Independent Review of Groundwater Remediation Strategy for Hexavalent Chromium and RDX Groundwater Plumes at Los Alamos National Laboratory

November-2022

NNLEMS-2022-00003

Figure 4. Figure 7 from Jordan et al., 2021. “Probabilistic Groundwater Modeling of the Chromium Plume at Los Alamos National Laboratory – 21165”. Original caption: Forward modeling results for the focus wells, using the MCMC posterior parameter sets from the uncertainty analysis. The LM (classical

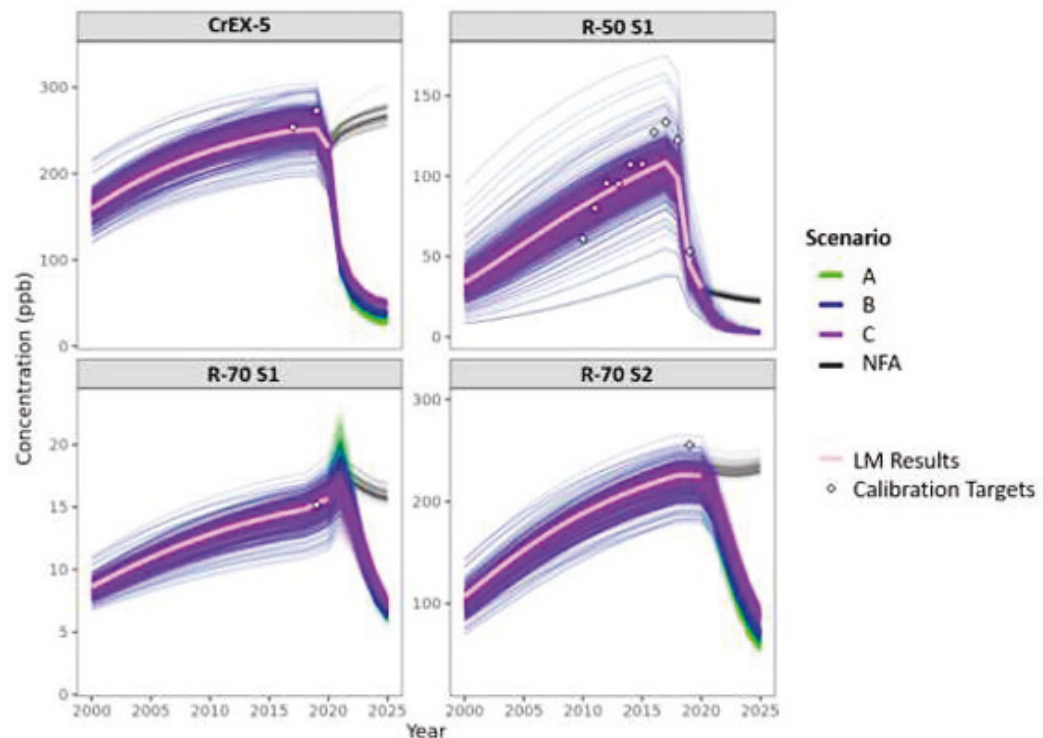
Interim calibration results for Cr(VI) presented in Jordan et al. (2021) were used to demonstrate workflow. However, their calibration results (Figure 4) do not adequately capture the breakthrough even though the data points are within the uncertainty bounds. The arrival time is different, and the shape of the breakthrough is not matched. We recognize that matching concentrations is quite difficult (Chen et al., 2020). Still, we have concerns that all the breakthrough curves (from the Monte Carlo (MC) simulations) vary only in magnitude but not in the arrival times.

- Changing the objective functions during the calibrations to moment-based metrics, so that the characteristic metrics (such as magnitude/arrival of breakthrough curves) are represented (Harvey et al., 1995; Nowak et al., 2006; Murakami et al., 2010),
- Checking whether the source zone area or dispersivity is not overestimated (Figure 7 in Jordan et al., 2021 suggests that the actual breakthrough is sharper),
- Considering the development of guided approaches that incorporate semiquantitative knowledge of geologic structures and depositional processes to maximize the fidelity of the hydraulic conductivity field to real-world conditions and to support improved future simulation of structurally controlled preferential flow and macro-scale matrix diffusion.
